UNITED STATES PATENT AND TRADEMARK OFFICE

APPLICATION NO.	FILING DATE	FIRST NAMED INVENTOR	ATTORNEY DOCKET NO.	CONFIRMATION NO.
10/633,296	07/31/2003	Michael Czysz	MCZ005	3325

Office Action Summary	Application No. 10/633,296	Applicant(s) CZYSZ, MICHAEL	
	Examiner Saúl J. Rodríguez	Art Unit 3681

DETAILED ACTION

Fig. 2

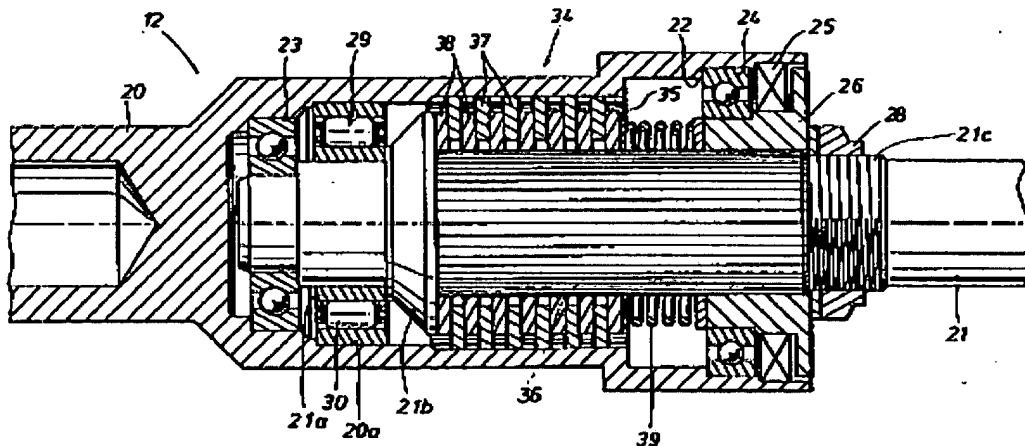
Claims 1, 4-5, and 8 are rejected under 35 U.S.C. 102(b) as being anticipated by Masuda et al. ('507).

Masuda et al. ('507) discloses a motor vehicle (Fig. 1), comprising a chassis, an internal combustion engine (E), a gearbox at a first end of the vehicle, a gearbox output shaft (10) wheels (18, 19), a slipper clutch providing positive sprag engagement and slip, sprags (30) at a second end of the vehicle, a clutch basket (20), a stack of drive plates (37, 38), and a spring (39).

FIG.1

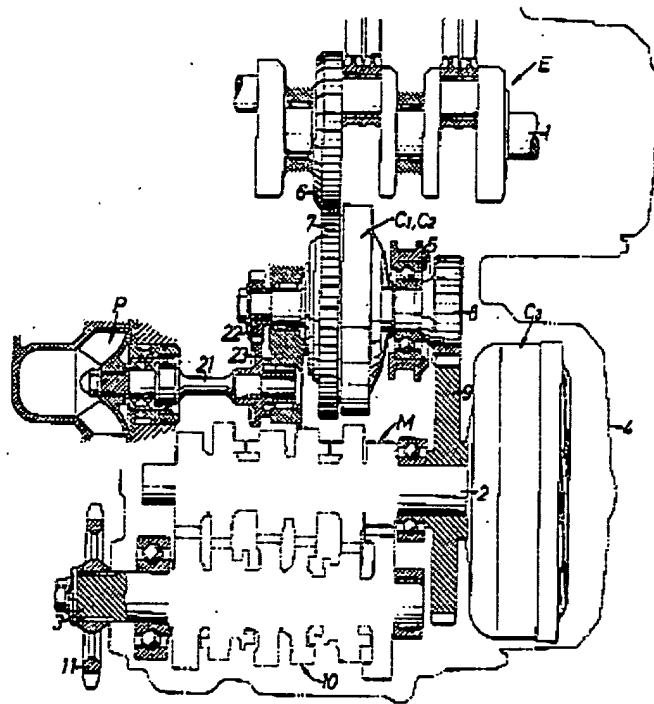
Gotoda ('989) discloses a motorcycle (Col. 1, lines 8-9) drivetrain (Fig. 1), an internal combustion engine (1) at a first end of the vehicle, a gearbox output shaft (3) at a second end of the vehicle, a conventional gearbox clutch (C3), a slipper clutch (C1, C2), a gear (9), a sprag coupling (14), a basket (17), drive plates (18, 19), and a spring (20).

Then, it would have been obvious to a person of ordinary skill in the art at the time the invention was made to use the concept of Masuda et al. in a motorcycle environment in view of Gotoda to improve the braking characteristics of the motorcycle.

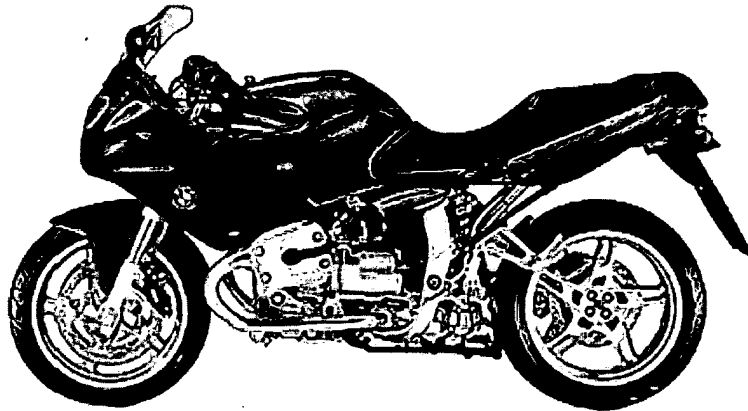
Concerning claim 15, Masuda et al. ('507) in view of Gotoda ('989) do not show a longitudinal engine. However, motorcycles have been known to have transversely and longitudinally mounted engines (e.g., BMW R-Series). Then, it would have been

obvious to one having ordinary skill in the art at the time the invention was made to orient the engine longitudinally for packaging, cooling and/or aerodynamic purposes.

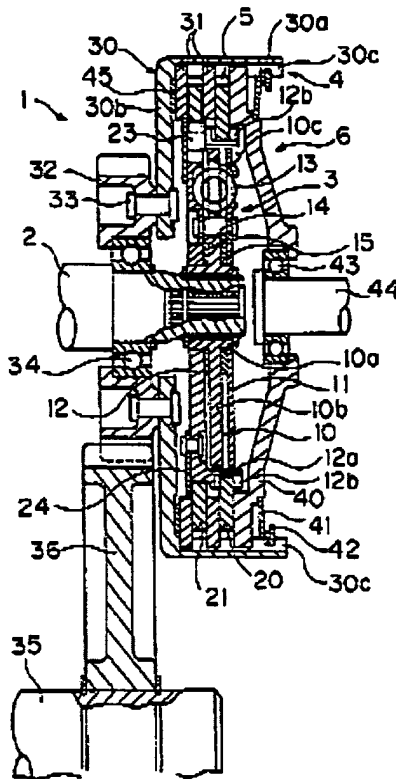
Masuda et al. ('507) in view of Gotoda ('989) does not show an adjustable slipper clutch.

Kajitani et al. discloses a motorcycle comprising a chassis (Col. 1, line 17), an internal combustion engine (Col. 8, line 41), a primary clutch (60), a positive engagement one-way clutch (68, Fig. 2), a crankshaft (51), a gearbox output shaft (49), a slipper clutch (Fig. 2), a clutch basket (60a), a stack of drive plates (67), a spring (71), an adjustable (Col. 7, 62-65) tensioner (75).

Then, it would have been obvious to a person of ordinary skill in the art at the time the invention was made to provide adjusting means to the device of Masuda et al. in view of Gotoda in further view of Kajitani et al. to tweak the braking characteristics of the bike to suit track conditions.
